DEVELOPMENT ASSESSMENT CASE NUMBER: CD-2016-0013 – Holdsworth Center

Presentation of a Project Assessment Report for the Holdsworth Center Planned Unit Development, located at 4907 RM 2222 Road, within the Lake Austin Watershed.

## MASTER REVIEW REPORT

# PROPOSED LAND USE PLAN

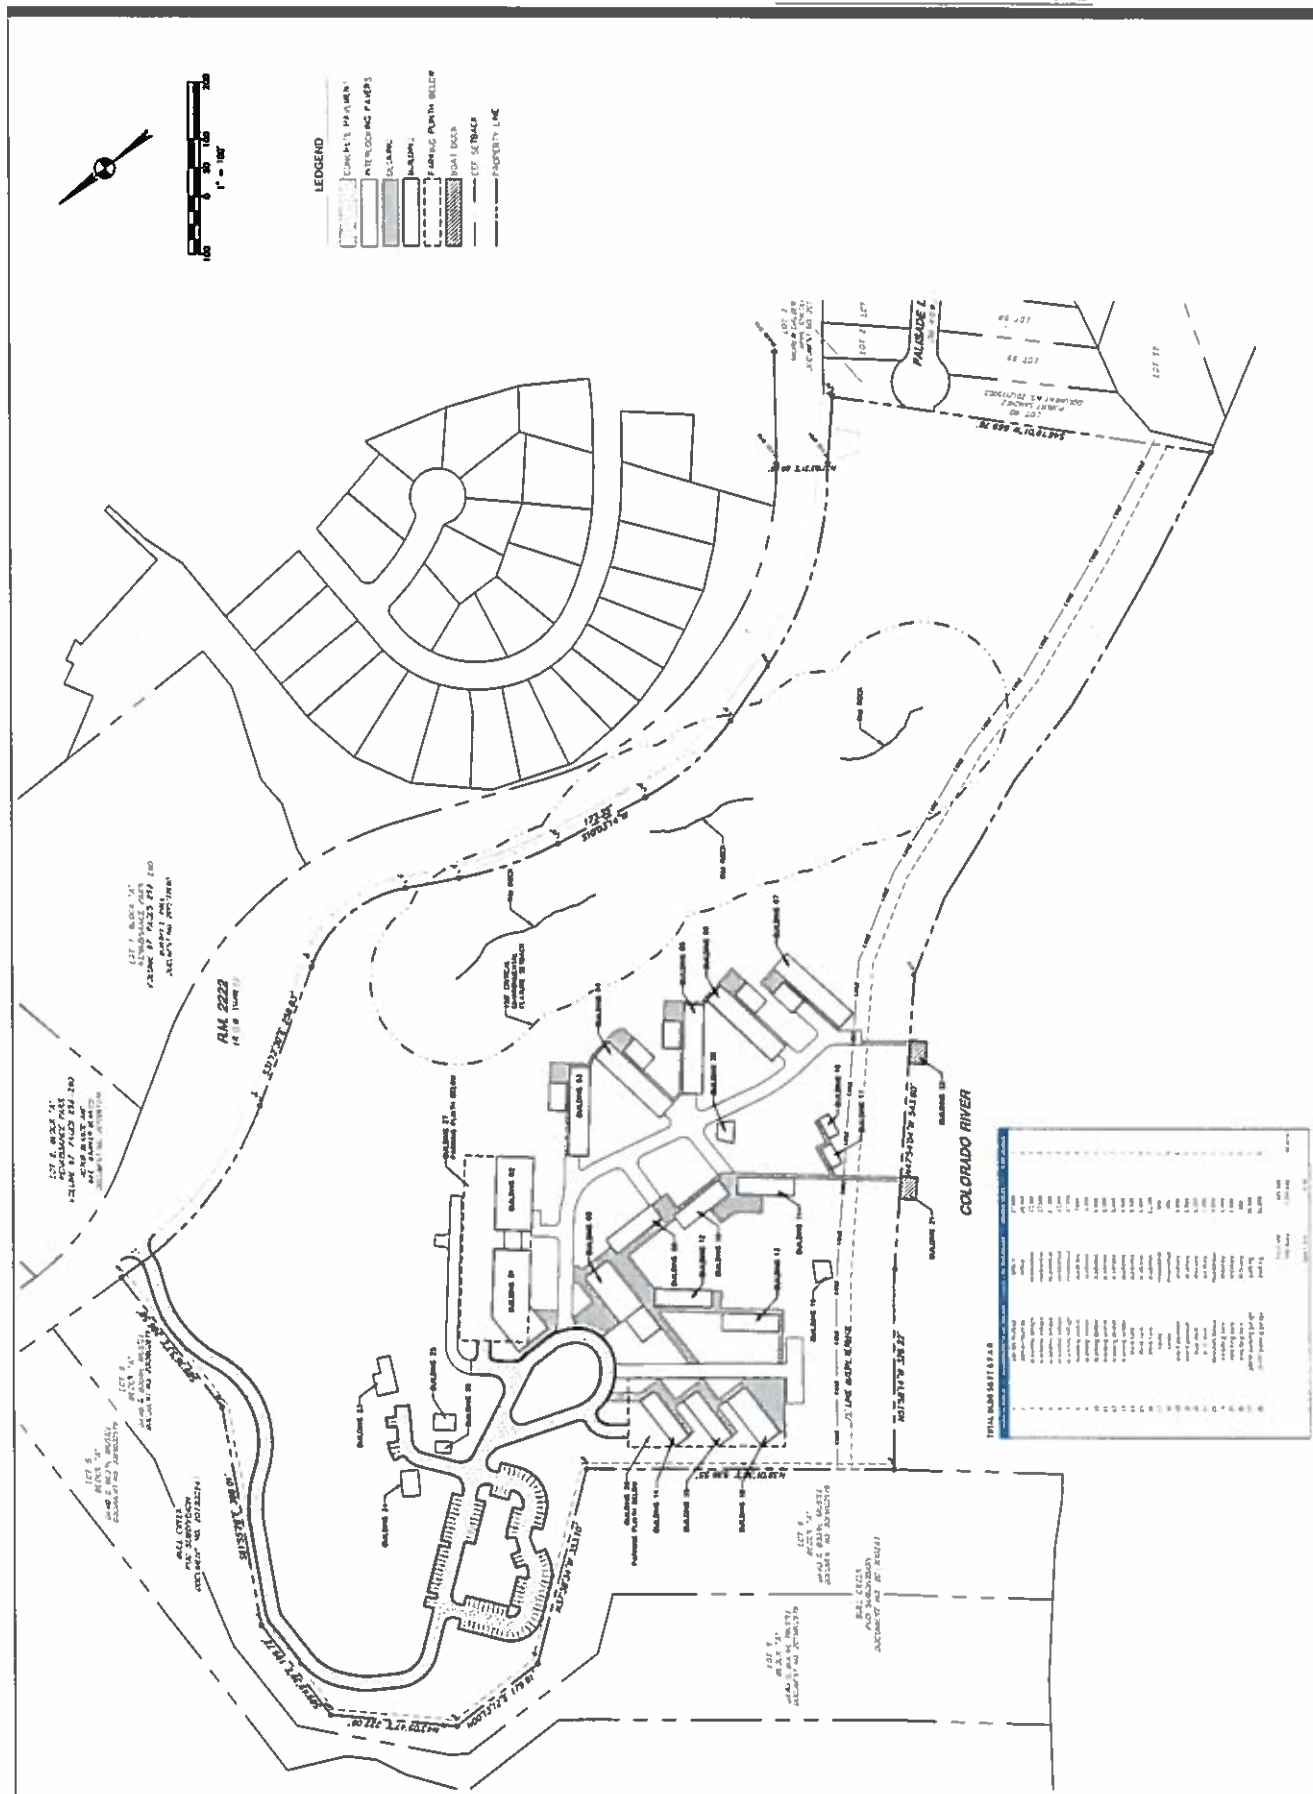
- HT 3 PUD note #12 should be modified to include not only Heritage trees but the remainder of the Tier 2 requirement on tree preservation that the PUD has committed to adhere too. Please revise this note to remove “where surveyed on the site” as trees may be missed during the PUD review process.

- HT 4 PUD note #16 speaks to plants included in the project coming from the Appendix N preferred plant list. For all tree planting on site the trees need to come from the Appendix F list and not the appendix N list.

- HT 5 PUD note #11 is one that would be more conducive to an urban infill type project where planting space is limited. With this project’s apparent commitment to open space and limiting impervious cover it would not appear that any plantings would need to be placed in a confined planting area and ample soil volume would be provided.

HG1. Exhibit C of the proposed PUD land use plan shows the location of 3 canyon rimrock features. Please label these features “Rimrock Critical Environmental Features.” Please update the land use plan to include show the more accurate locations obtained for these features and to add the locations of the bluff (B1), the seep (S1) and a fourth canyon rimrock (RR4).

HG2. Exhibit C of the proposed PUD land use plan shows the location of a 150-foot radius “Critical Environmental Feature Setback” that encompasses 3 canyon rimrock CEFs. Please label this line as “150’ Rimrock Critical Environmental Feature buffer.” Please do not include the area of the CEF buffer that overlays the right-of-way and pavement of R.M. 2222 within the CEF buffer. The initial site layout showed 150-foot radius CEF buffers around three canyon rimrock CEF features (RR1, RR2 and RR3). The buffer locations need to be revised to reflect the more accurate locations of each, as determined by follow up work conducted by Horizon following the February 2, 2017 site visit, and to include the three additional CEFs.

ZN 1. Add a vicinity map to the Land Use Plan and submit an 8 ½ x 11 copy to the case manager.

ZN 2. Please identify adjacent land uses on the Land Use Plan.

ZN 3. Please identify the floodplain areas on the Land Use Plan.

ZN 4. Change the reference from Colorado River to Lake Austin on the Land Use Plan.
